**WLD3 - Replace Engine Mounts and Retrofit Caps (Workshop Campaign)**

Model Line: **911 (992)**

Subject: **Engine mount**

Overview of engine mounts (PADM)

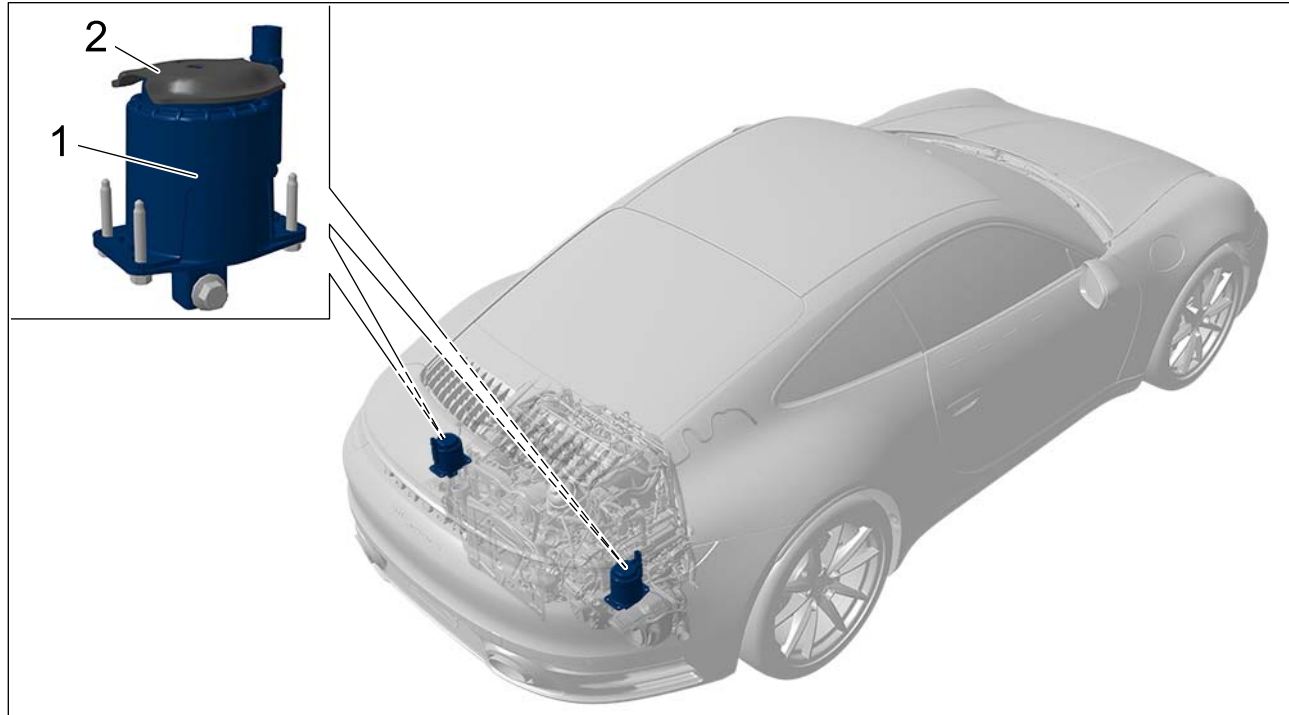
- 1 – Engine mounts PADM (**replace**)
- 2 – Cap for engine mount (**retrofit**)

The engine mount caps to be retrofitted within the scope of the present campaign differ in shape from those shown and are installed directly onto the relevant engine mount.

*Installing cap*

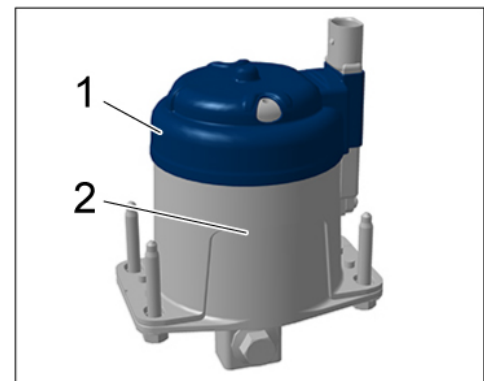
- 4 Install the cap to be retrofitted on the **new engine mount**.  
For this purpose, thread the electric plug connection through the cap ⇒ *Installing cap -1-* and then push the cap as far as it will go onto the engine mount ⇒ *Installing cap -2-*.
